Location Address: 2231 FILLMORE ST and 2224 PIERCE ST, HOLLYWOOD FL 33020

Explanation of Request: NEW CONSTRUCTION, 63 UNIT, RENTAL APARTMENT BUILDING

**SUBJECT:** Preliminary Site Plan review for a 63 Unit residential development.

# FILLMORE STREET APARTMENTS

**A-1.1**

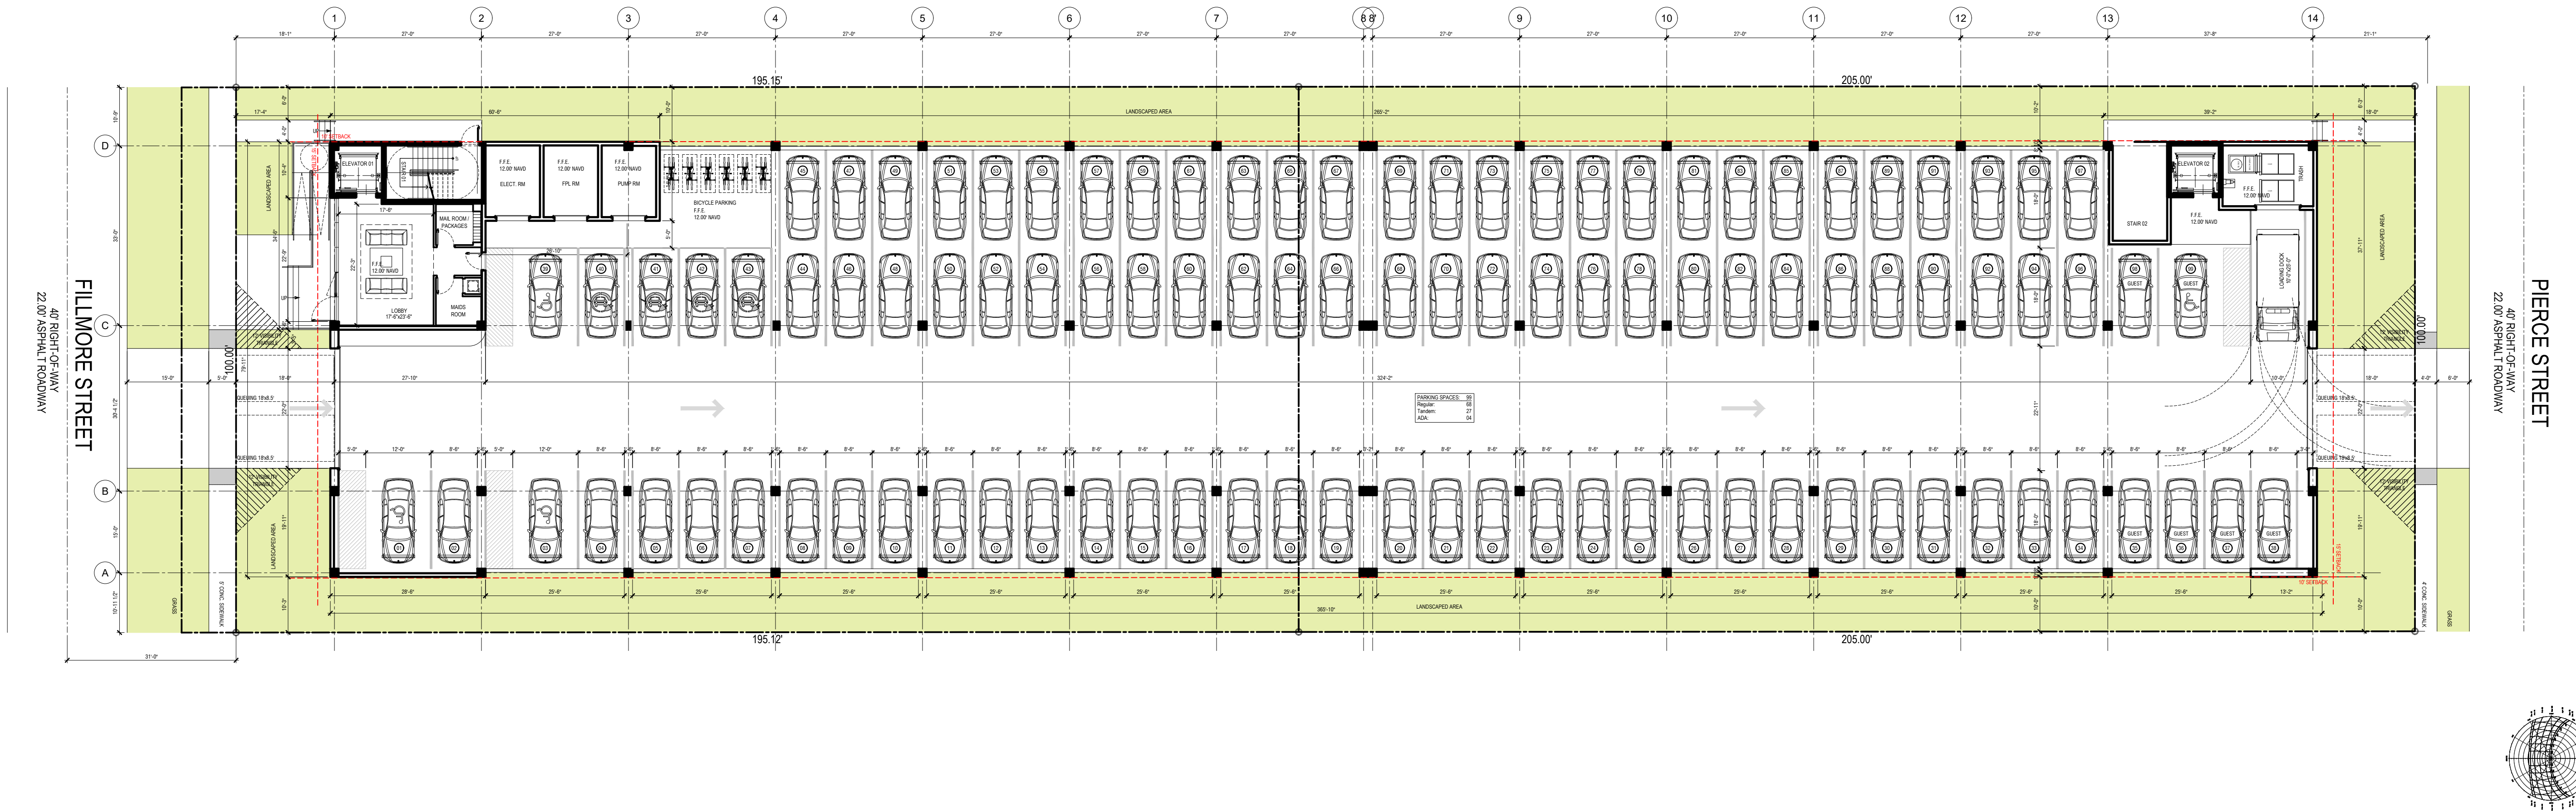
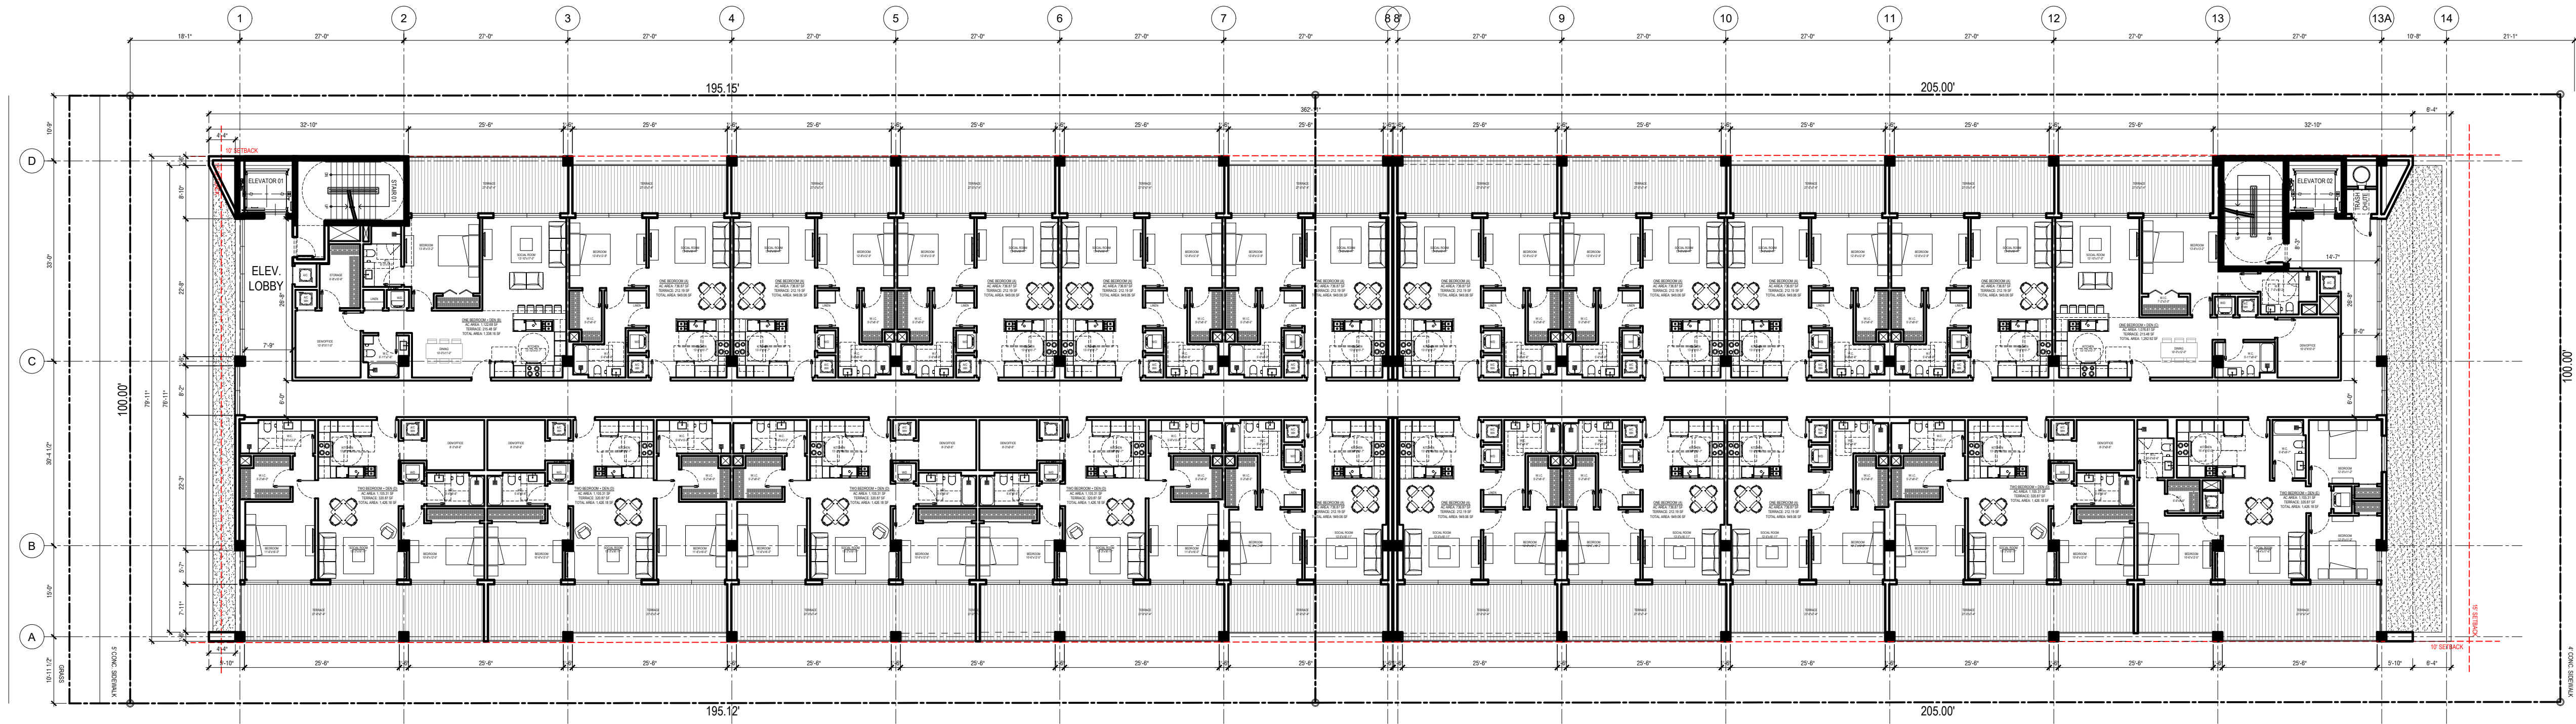
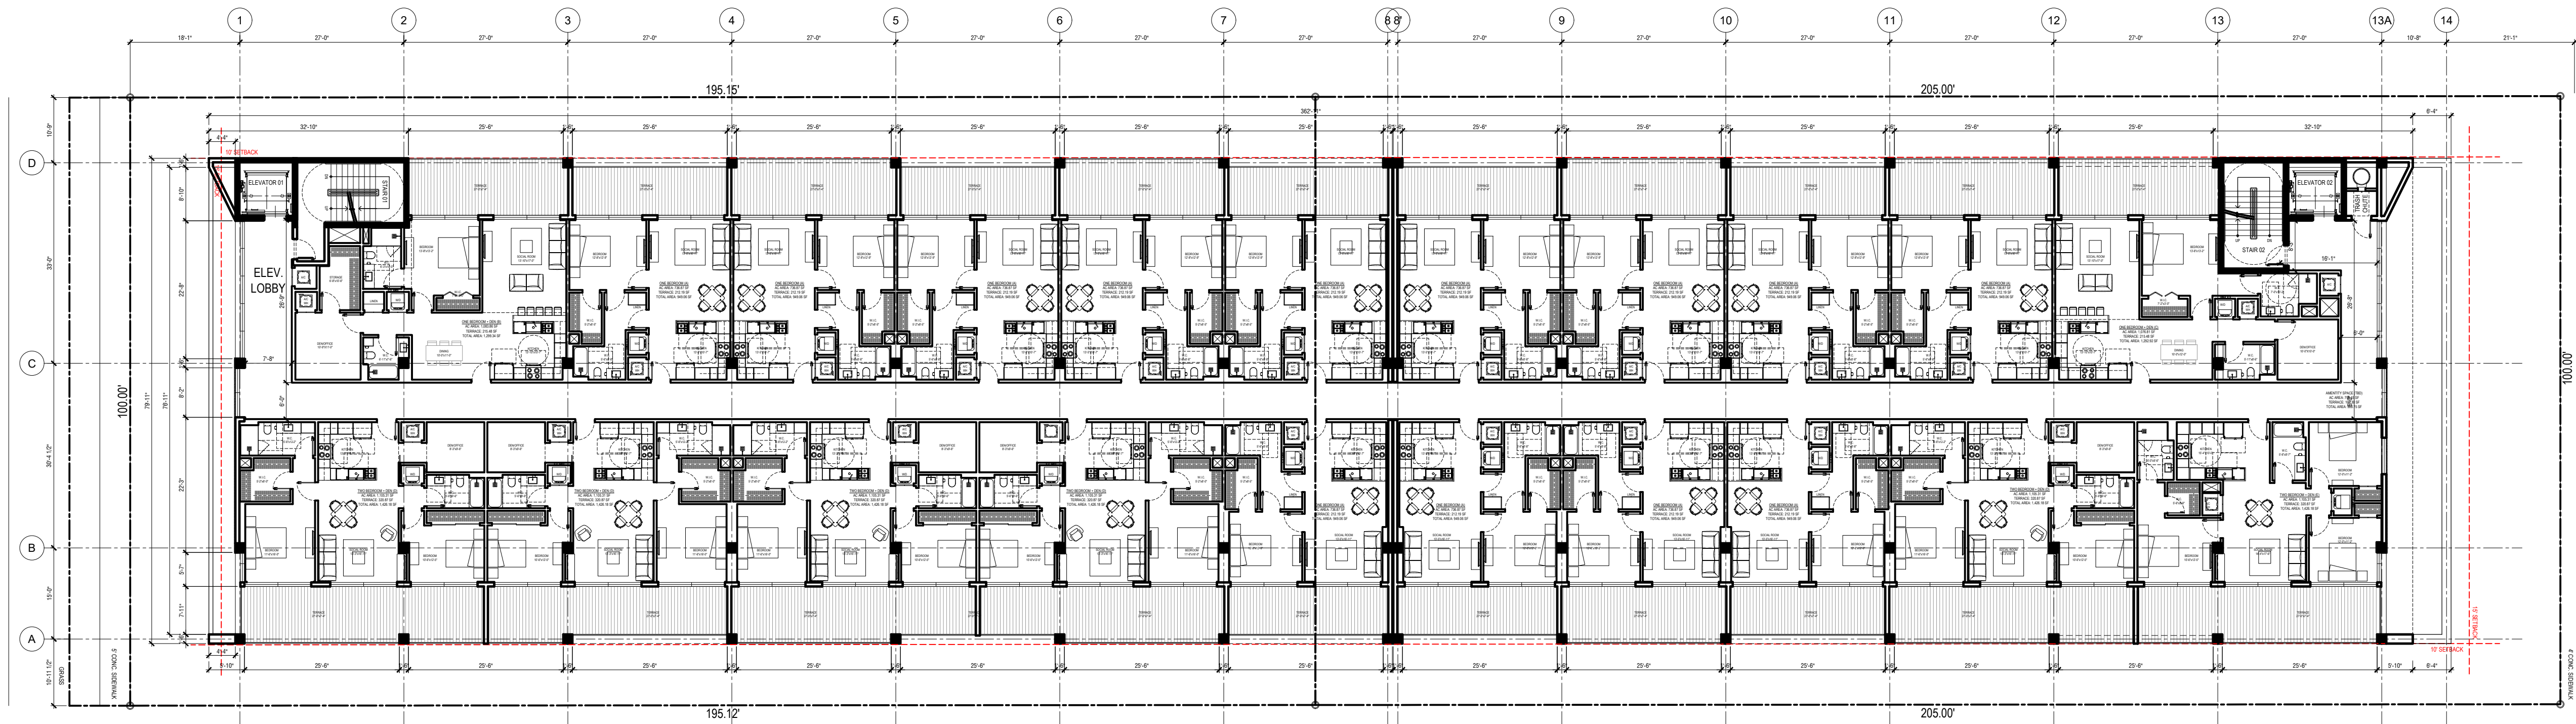
- a. The Site Plan shall be along the Site tabulation data.  
**Please see attached revised Site Plan Sheet A-1.1 with the requested information.**
- b. Include a note on the site plan indicating that all changes to the design will require planning review and may be subject to Board approval.

**Please see attached revised Site Plan Sheet A-1.1 with the requested note at the bottom.**
- c. Is the entrance to the parking lot through Fillmore Street and the exit through Pierce Street?

- d. Do both driveways at the entrance and exit from the at-grade parking have a gate? What material? Provide a detail.  
**Correct. We are proposing a gate at grade at both Pierce Street and Fillmore Street. Please see the attached revised Sheet A-1.5 to show the information about the subject doors. They are going to be aluminum louvered doors.**

- e. Provide visibility triangles at all driveway accesses.  
**Please see attached revised Site Plan Sheet A-1.1 with the requested visibility triangles as requested.**

- f. Provide a queuing vehicle at entrance of parking lot and another queuing vehicle at exit.  
**Please see attached revised Site Plan Sheet A-1.1 with the requested queuing shown within our own property.**

- g. The at-grade parking shall have landscape around to block visibility from right of way.  
**Understood. Please see attached revised Site Plan Sheet A-1.1 with the requested landscaping around the parking.**

- h. The dimensions on the Site Plan on the landscaped area are not clear.  
**Please see attached revised Site Plan Sheet A-1.1 with the requested dimensions shown clearly for the landscaping areas.**

- i. Provide EV charging stations per Code of Ordinances 151.154. These parking spaces shall not be assigned to any of the units.  
**Please see attached revised Site Plan Sheet A-1.1 with the requested EV charging spaces for 40-43.**

- c. Include the ratio of required guest spaces per unit (min. 1 per 10).  
**Please see attached revised Site Plan Sheet A-1.1 with the required parking shown at 1 per 10.**

- d. Include the number of required and proposed ADA spaces.  
**Please see attached revised Site Plan Sheet A-1.1 showing the require and proposed ADA spaces.**

- e. Include the provided FAR as a ratio, not just the overall provided square footage.  
**Please see attached revised Site Plan Sheet A-1.1 with the requested FAR required and proposed.**

- f. Per Sec. 4.6.B.3.a.(7), include the minimum required and provided dwelling unit sizes and cumulative averages.  
**Please see attached revised Site Plan Sheet A-1.1 with the dwelling unit sizes.**

6. Identify location of guest parking spaces on the site plan.  
**Please see attached revised Site Plan Sheet A-1.1 with the guest spaces shown in spaces 35-38, 98 and 99.**

7. Tandem parking spaces shall be assigned to one unit only and not be used for guest parking. Provide a note on the Site Plan.  
**Please see attached revised Site Plan Sheet A-1.1 with the requested note at the bottom.**

**Correct. We are proposing a one-way entrance and exit. There is an entrance on Fillmore and an exit on Pierce to simplify traffic flow. Please note the directional arrows shown on Sheet A-1.1.**

**Please see attached revised Site Plan Sheet A-1.1 with the requested removal of unneeded items.**

**Please see attached revised Sheets A-1.1 with the requested EV chargers to be provided with electrical infrastructure.**
